SERVICE BULLETIN

Piper Aircraft Corporation

Subject:

Wing Fuel Tank Cap Modification

INSTRUCTIONS

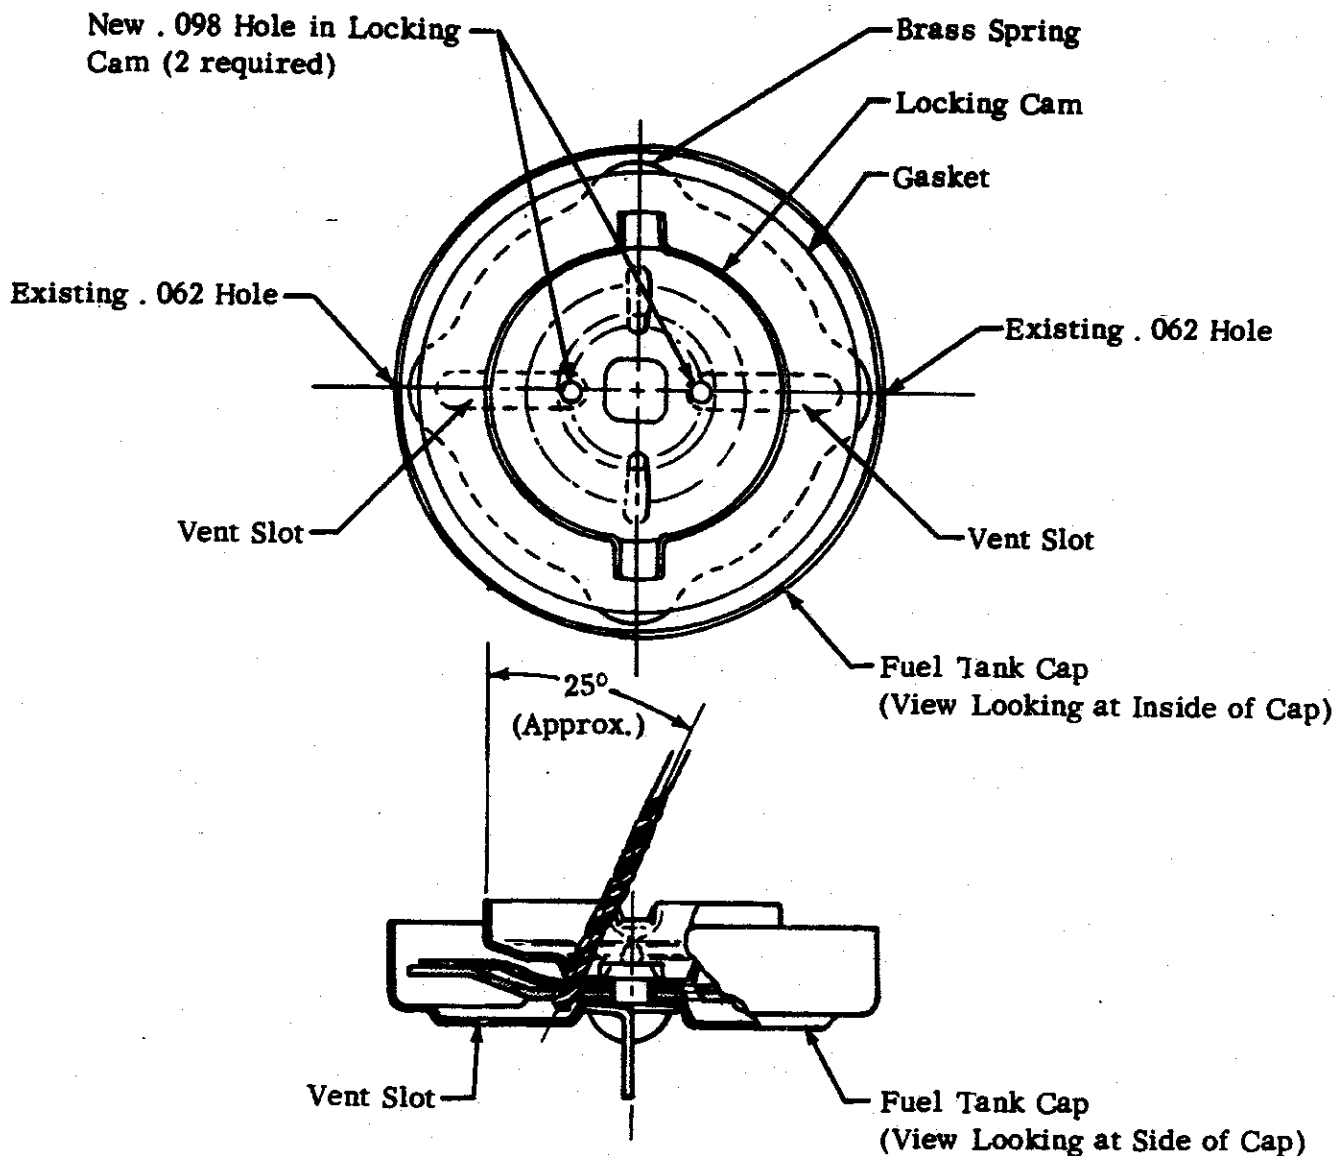
Purpose: Piper Service Bulletin No. 522 dated September 28, 1976 referred to a condition wherein inadequate fuel tank venting could result in fuel tank collapse, and provided instructions to drill two (2) .062 in. vent holes in the fuel tank cap.

A recent fuel tank collapse was attributed to inadequate venting, caused by obstruction of the cap vent holes (installed per above referenced Service Bulletin). Accumulation of foreign material (corrosion, dirt, ice, etc.) inside the cap "sealed off" the cap internal vent slots.

This service release provides instructions to drill two additional vent holes in the cap assembly to insure adequate venting -- in the event that the present vent slots (located in the cap locking cam plate) are obstructed and recommends cleaning and inspecting present vent slots.

1. Remove fuel tank caps from wings and rework caps as follows:
 - a. Locate and mark center of two .098 holes on locking cam of cap as shown. Use existing .062 vent holes to index location of new .098 holes.
 - b. Drill two .098 holes (#40 drill) through locking cam. Angle drill to intersect end of vent slots as shown. **CAUTION: Do not allow drill to go through top cover of cap.**
 - c. Insert .032 wire in existing .062 holes. End of wire will be seen in new .098 holes if holes were correctly drilled.
 - d. With .032 wire in .062 holes, slide wire back and forth to loosen any corrosion or dirt that may be in the vent slots. Clean cap thoroughly with compressed air.
2. Reinstall reworked fuel tank caps and make proper Logbook entry of Service Bulletin 573 compliance.
